SFO NO. VA-101-13-I-0004

MONTEREY, CALIFORNIA

JOINT INTEGRATED VA / DAH HEALTH CARE CENTER

SITE DESIGN PROPOSED MODIFICATIONS

EXTERIOR DESIGN

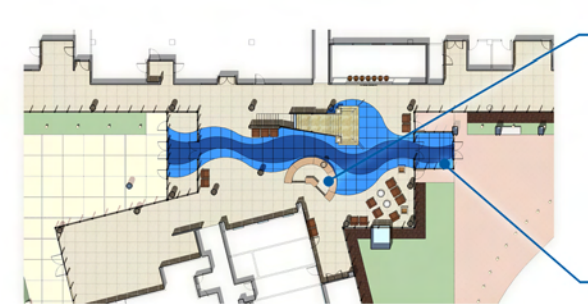
1
 Enhancement: Window louvers.
 Why: The adjustable metal shade louvers allow control of solar heat gain on the south-facing exposure, while allowing natural light to enter the building. Views to the exterior are preserved.

2 EXTENDED ROOF
 Enhancement: Extended roof at walkway.
 Why: The covered walkway has been widened to provide maximum protection for visitors exiting vehicles at the drop-off area. Additionally, the walkway roof now provides coverage for all entry/exit doors at the front of the building, and is visually connected to the building.

3 LIGHT SHELF
 Enhancement: Window shape/light shelf.
 Why: The solar heat gain on the south-facing windows can be controlled/limited, creating more comfortable work areas. The shade elements penetrate the glazing plane, providing a "light shelf" which reflects natural light deeper into the room, thereby reducing artificial lighting requirements and lowering energy costs.

4 TOWER ELEMENT
 Enhancement: Parapet tower element.
 Why: The new "tower fin" at the lobby intersection serves multiple purposes:
 a. The roof parapet screens from view the tall code-required smoke extractors above the glass lobby.
 b. The "tower" element helps unify the building design composition by bridging the glass lobby.
 c. The "tower" provides a distinct way-finding device for veterans visiting the facility for the first time, indicating the point of entry.
 d. The top of the parapet provides a clearly-visible location for signage or the VA logo.

5 COVERED ENTRY
 Enhancement: Covered area at west entry.
 Why: Adding a roof area at the west entry provides multiple benefits to the user groups:
 a. The roof element provides a signage location, assisting visitors with way-finding.
 b. The covered area provides protection from sun, rain, and wind from approaching storm systems.
